TRANCHE 8: EXPOSURE DRAFT

PROPOSED ELECTRICITY SYSTEM AND MARKET (ESM) AMENDING RULES

Explanatory Note for Exposure Draft of the Tranche 8 Proposed ESM Amending Rules

Method based on WEM ESOO dispatch modelling

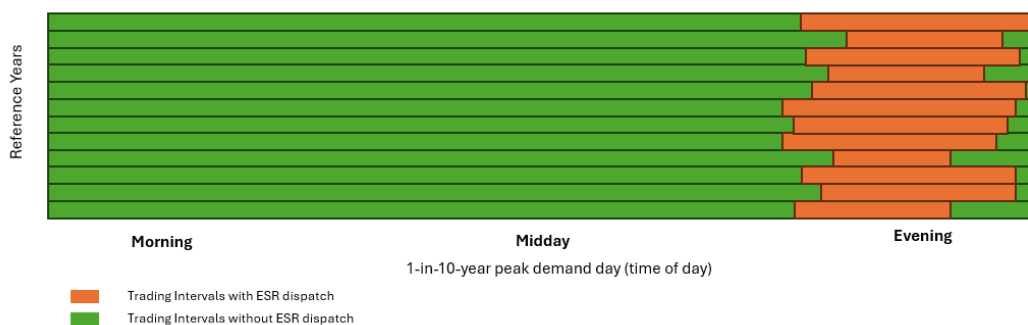
EPWA developed and assessed a method based on WEM ESOO dispatch modelling results. This method undertakes Limb B dispatch modelling according to the WEM ESOO methodology and uses the modelling results of the ESR dispatch data. The method takes the top 1 day in the modelled future year of interest and determines the number of half-hourly intervals over which the ESR is dispatched. This number of intervals would establish the ESROD.

This method was excluded due to high volatility of ESROD from year to year and difficulty to predict the ESROD. This method was also excluded based on its difficulty to implement. This method requires market dispatch modelling in line with WEM ESOO limb b assessment methodology.
